RE: *Martlock Property*  
*F 96-10*  
*(razing of existing house)*

RE: F-99-43, Revision Plat, Martlock Property, Lots  
1-3

MARTLOCK PROPERTY  
CHRONOLOGY OF COMMENTS

RE: Rev. Comm  
Martlock Prop

*Martlock Resub Copy Signed Final*

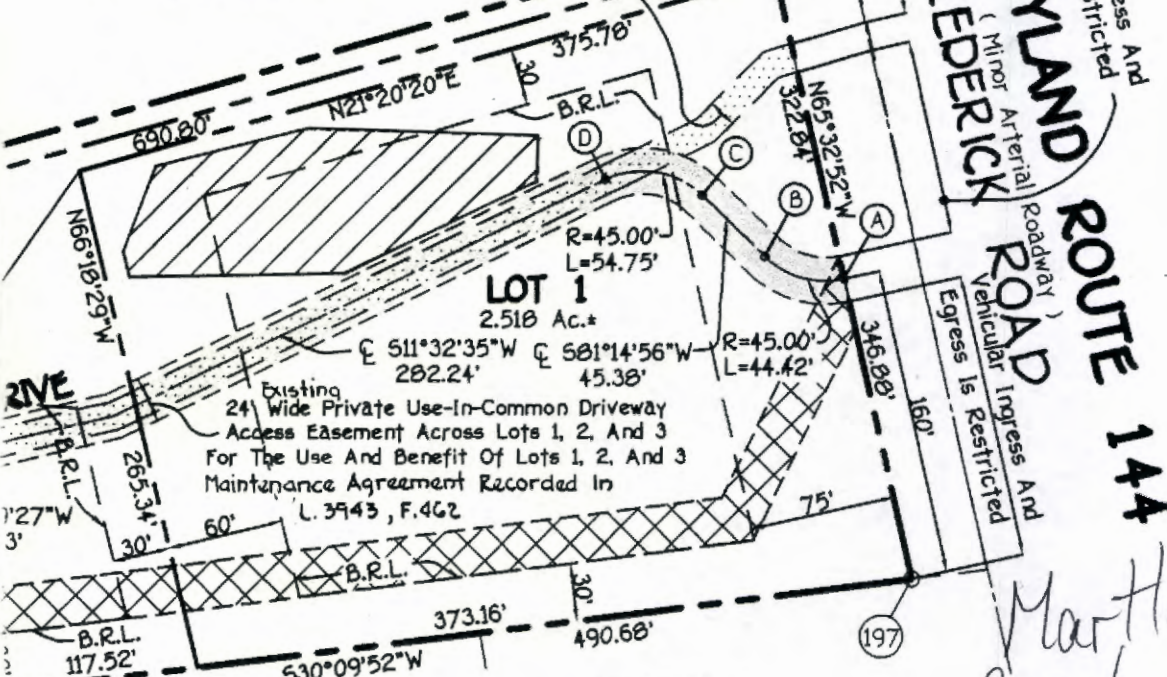
15. Existing Structure On Lot 1 Shall Be Abandoned. No New Buildings, Extensions, Etc. Shall Be Constructed At A Distance Greater Than 10 Feet From The Centerline Of The Proposed Driveway That Meets The Following Conditions: 1) Proposed Use In Common Right-Of-Way Recorded In The Records Of The County.

The Purpose Of This Plat Is To Create A New Access Easement For Lots 1, 2 And 3 And To Abandon The Existing Private 24' Wide Use In Common Access Easement As Recorded On Plat No. 12371 And To Identify The Private Driveway As "Martlock Drive".
